REVISED PUBLIC NOTICE

File Number: 2025-03-013

for a State of Rhode Island Assent to construct and maintain: The Sakonnet Point Club is proposing to install a saltwater intake structure at the existing diffuser location and relocate the diffuser about 300 feet to the east (Sheet C-05, C-06, and C-07). A proposed pump station will pull water from the intake structure and pump it through the reverse osmosis treatment system (Sheet C-05). This will require both waterside and landside improvements

SALTWATER INTAKE PROJECT
SAKONNET POINT CLUB
TOWN OF LITTLE COMPTON, RHODE ISLAND

DISCHARGE LINE PROFILE

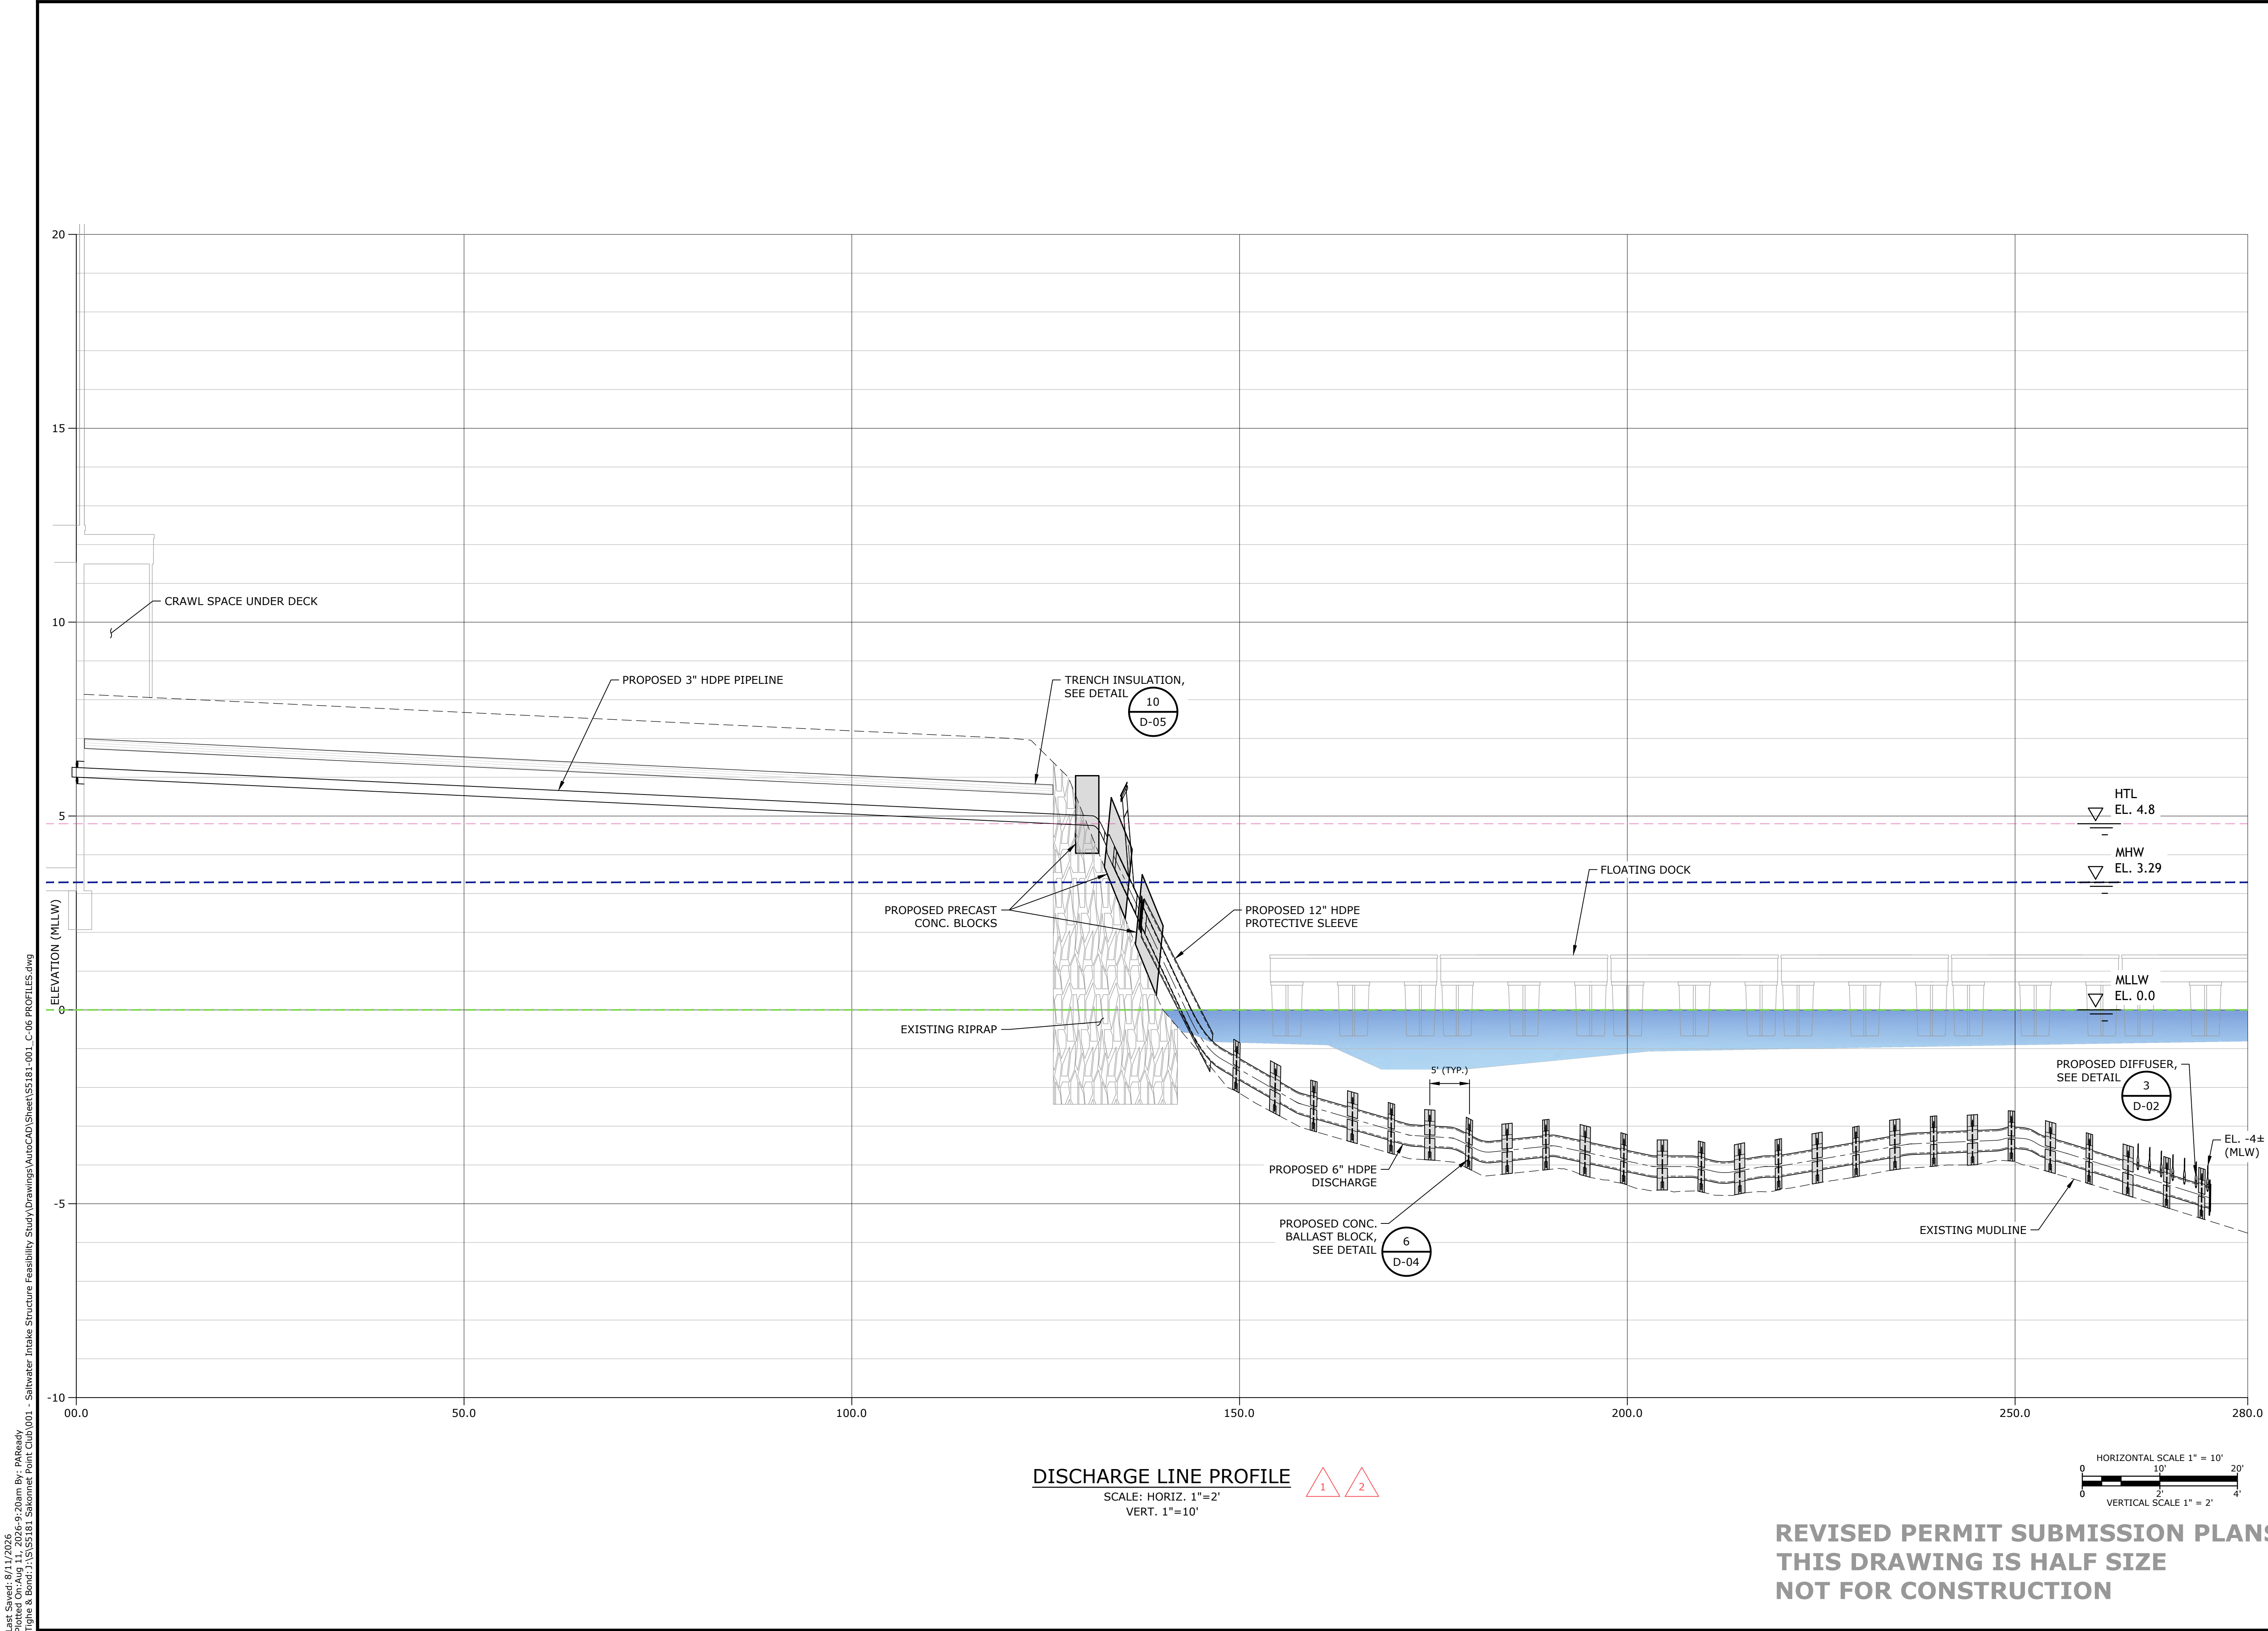
In addition to the diffuser revisions, the alignment of the discharge diffuser pipeline was revised to keep the majority of the line below the SPC's existing but different floating docks to the north-west, where it will be better protected. This increased the layout length from about 72 to 129 feet and increased the number of concrete ballast blocks from 11 to 26. This also necessitated minor changes to the ballast blocks, causing some of their dimensions to be reduced slightly.

DISCHARGE DIFFUSER DETAILS

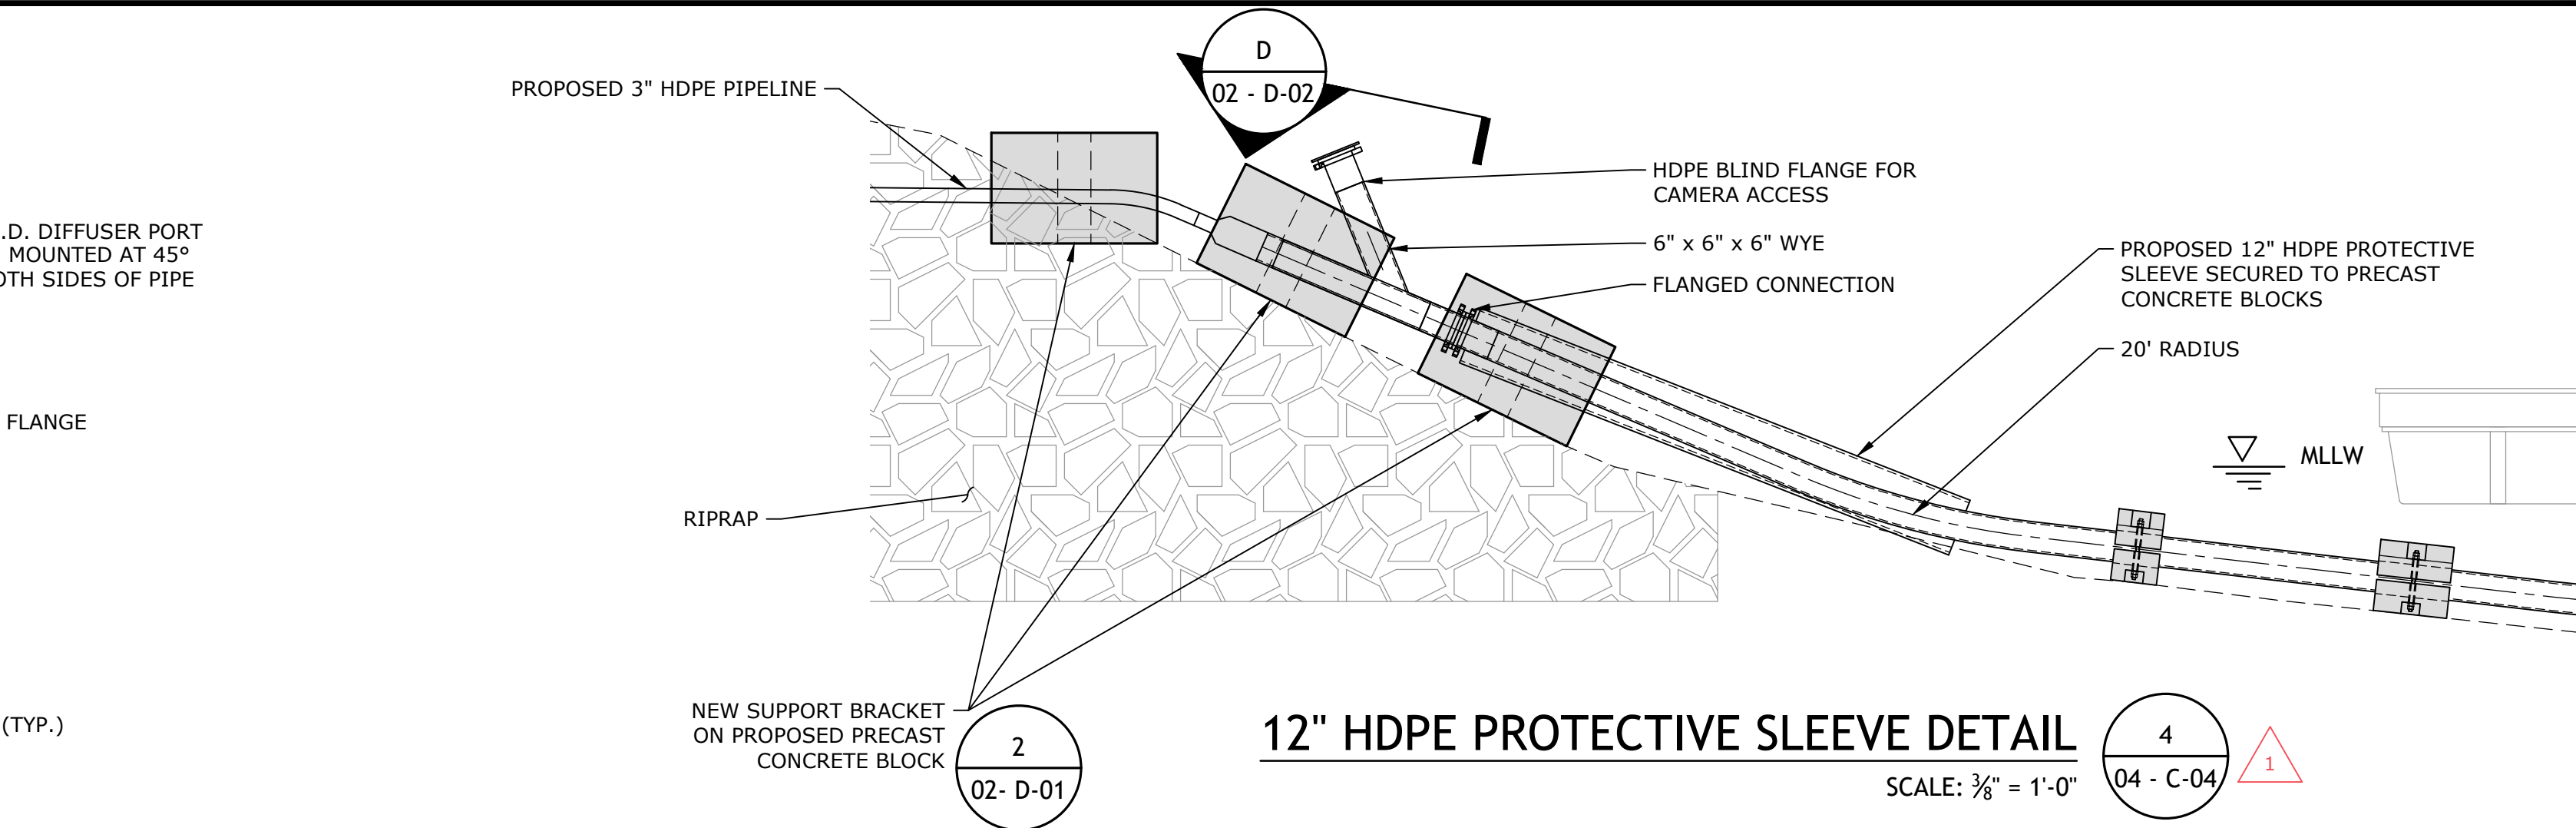
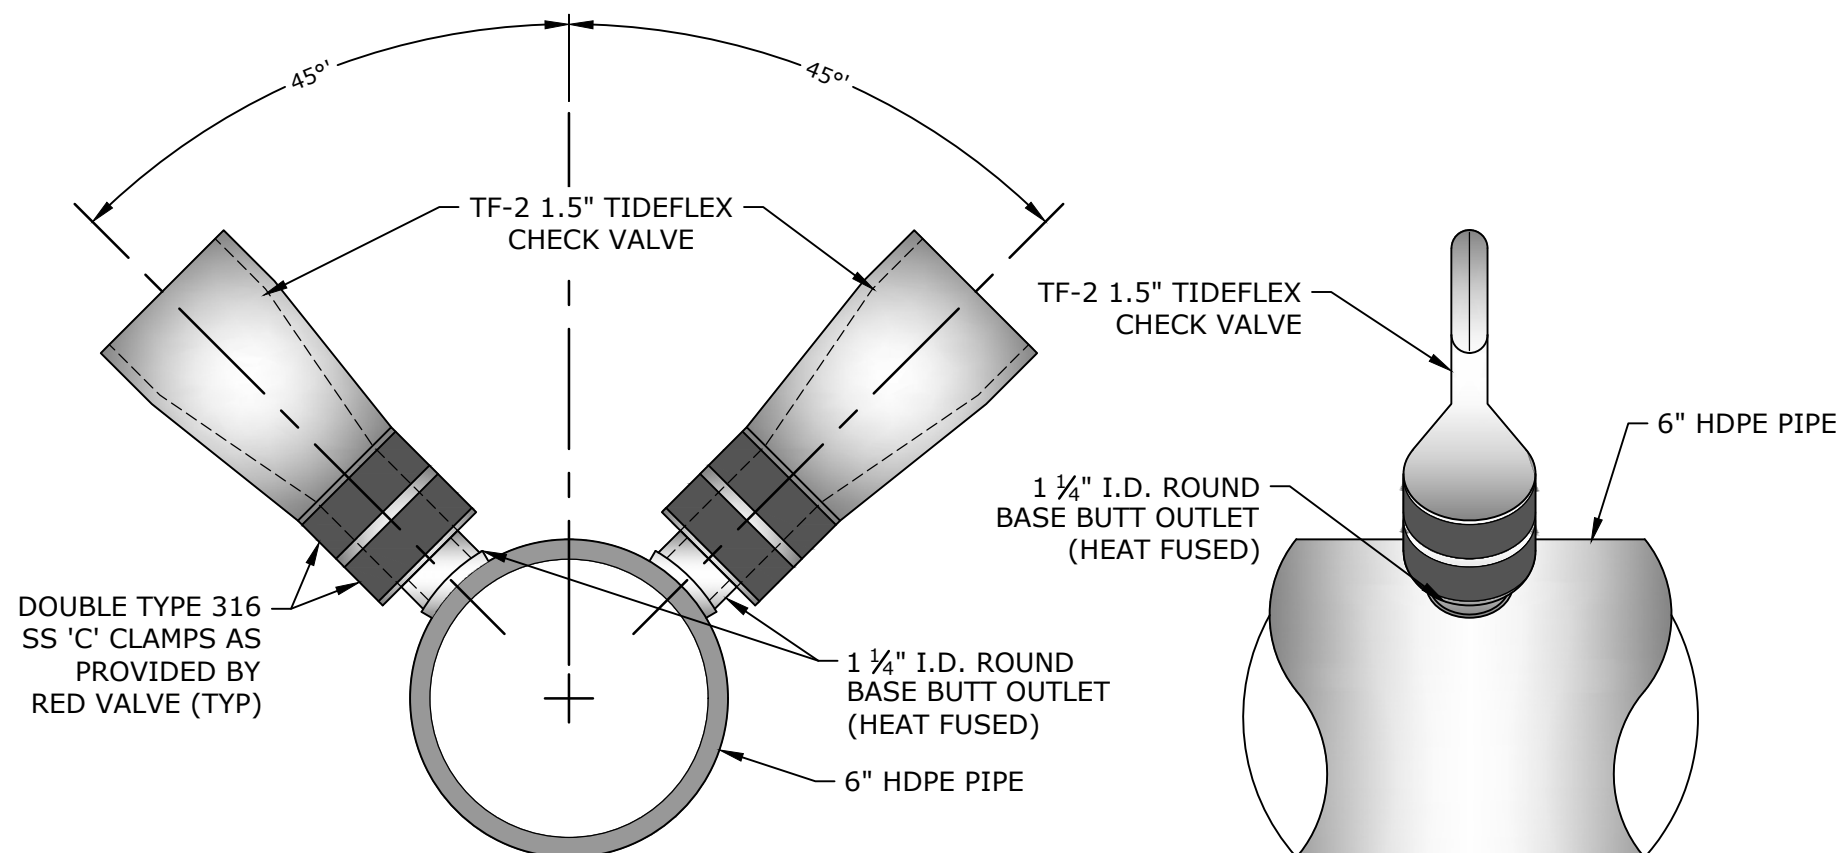
During the course of completing the modeling, it was determined that the originally proposed discharge diffuser configuration, consisting of seven (7) vertically oriented TF-2 Tideflex Check Valves (2" OD), spaced about 1.5 feet apart, would not be adequate to achieve the required dilution under the near field CORMIX modeling condition.

Through an iterative process, It was determined that a diffuser configuration consisting of fourteen (14) TF-2 Tideflex Check Valves (1.5" OD), oriented opposite each other and at 45 degrees, and spaced about 1.5 feet apart, was a more functionally efficient layout.
